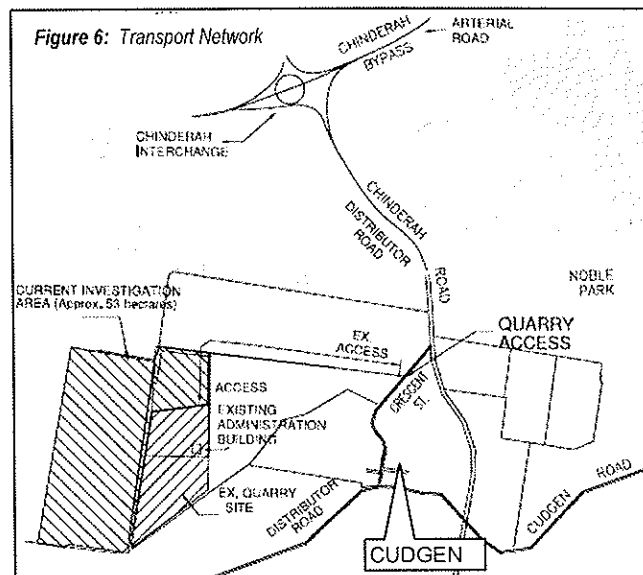
The truck access route from the proposed quarry extension to the arterial road network would follow the existing route, that is via an 'Access Road' on the northern side of the site, left into Crescent Street, left into Chinderah Road² and (generally) right onto the Pacific Highway (see Figure 6). Trucks would only travel through Cudgen Village for local deliveries.
